Subject: MHI's Second Responses to US-APWR DCD RAI No. 804-5938 Revision 3 (SRP section 03.12)

Second Responses to Request for Additional Information
No. 804-5938, Revision 3

US-APWR Design Certification

QUESTION NO.: RAI 03.12-29

Fig. A1-1 Summary for evaluating the structural integrity at the top of the cavity flow

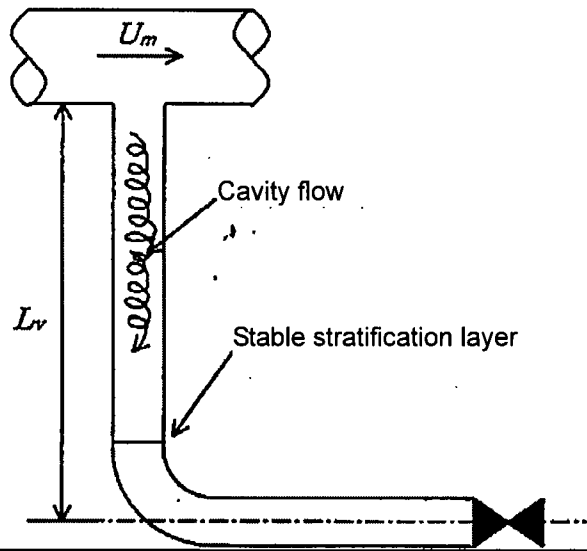
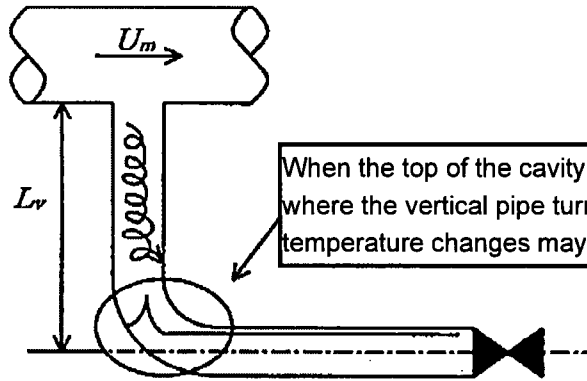
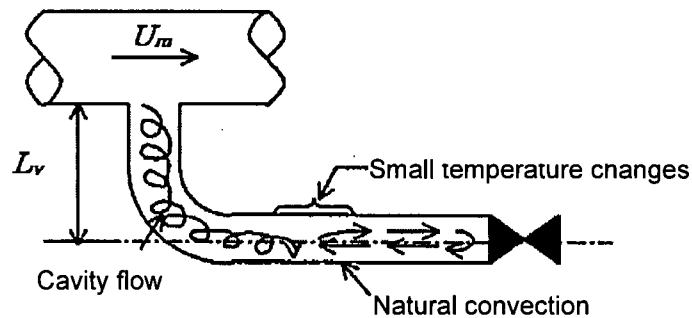
DCD Tier 2, Section 3.12.5.9 discussed thermal cycling in piping connected to the RCS. In their RAI 3.12-17 response (ML0933380324), MHI stated that the piping is routed such that a stratified surface boundary does not occur at horizontal pipe bends and elbows. However, MHI did not provide discussion for the piping routing methodology in the DCD mark-up. The staff is requesting MHI to provide piping stratification prediction method. In general, US utilities followed MRP-146 model for predicting and evaluating thermal cycling for PWR stagnant lines. MHI provided research results of ICONE 10- 23340 and ICONE 11-36214. However, ICONE 11-36214 identified that predictive accuracy of the evaluation method is about + 20 percent from the limited experiment data. If MHI model is not consistent with MRP-146 model which has shown benchmarking results to be effective in predicting the location of thermal cycling in branch line attached to RCL, MHI should identify the difference and provide justification.

In their RAI 3.12-17 response, MHI stated that as verification of actual equipment, confirmation is made such that there is no stratification surface boundary (top of cavity flow) at pipe bends and elbows migrating horizontally from vertical risers by performing temperature measurement for actual equipment of isolated branch pipes around RCS during initial startup test. However, the staff reviewed DCD Chapter 14 verification programs which did not mention any activity related to the stratification surface boundary verification. The staff is requesting MHI provide additional information for the test abstract including stating the standard operating conditions in DCD Chapter 14 that identifies the Objective, Prerequisites, Test Method, Data Required, and Acceptance Criteria for unisolable piping connected to the RCS to address NRC Bulletin 88-08. In general stratification verification monitoring activity shall be the COL's responsibility. However, this activity has not been listed as COL action item in the DCD. The staff asked MHI to clarify the responsibility. If this activity is to be completed by COL, the DCD should be modified to add this activity as a COL action item.

If the top of the cavity flow (i.e., the swirling penetration flow) entering a branch pipe from the Reactor Coolant Loop (run pipe) is located at a bend and thermal stratification occurs, where the downward vertical pipe turns horizontal, adverse thermal cycling, induced by swirling penetration flow only, may occur without the process due to valve seat leakage. Therefore, since the package of "JSME S 017-2003 "Guideline for Evaluation of High-Cycle Thermal Fatigue of a Pipe" (hereinafter, "the JSME Guideline") does not include the knowledge for predicting and evaluating thermal cycling for the PWR stagnant lines, MHI will avoid this adverse thermal cycling through the piping routing design.

In order to prevent the top of the cavity flow from being located at a pipe bend or an elbow, MHI will predict the penetration depth of cavity flow in accordance with the JSME Guideline. ICONE-10-23340 and ICONE-11-36214 essentially explain the empirical knowledge contained in the JSME Guideline.

As for the piping routing methods, MHI will develop the ASME Class 1 pipe routing design based on the guidance in the JSME Guideline to meet either of the following criteria (See Attachment 1). If a piping route satisfies the criteria, no further evaluation is required in piping routing design. This design approach is the same as that of the MRP-146 guidance. MHI will add a description of this approach in the DCD Tier 2 Subsection 3.12.5.9 as follows:

- a. The length of the vertical pipe between the Reactor Coolant Loop (run pipe) and the horizontal pipe should be longer than the predicted penetration depth (maximum depth) of the cavity flow. In this case, the stratification layer is stable in the vertical pipe and therefore significant thermal cycling does not occur.
- b. The length of the vertical pipe between the Reactor Coolant Loop (run pipe) and the horizontal pipe should be shorter than the predicted penetration depth (minimum depth) of the cavity flow. In this case, the cavity flow at a temperature equal to the water temperature in the run pipe keeps the water temperature in the horizontal pipe high and therefore significant thermal cycling does not occur.
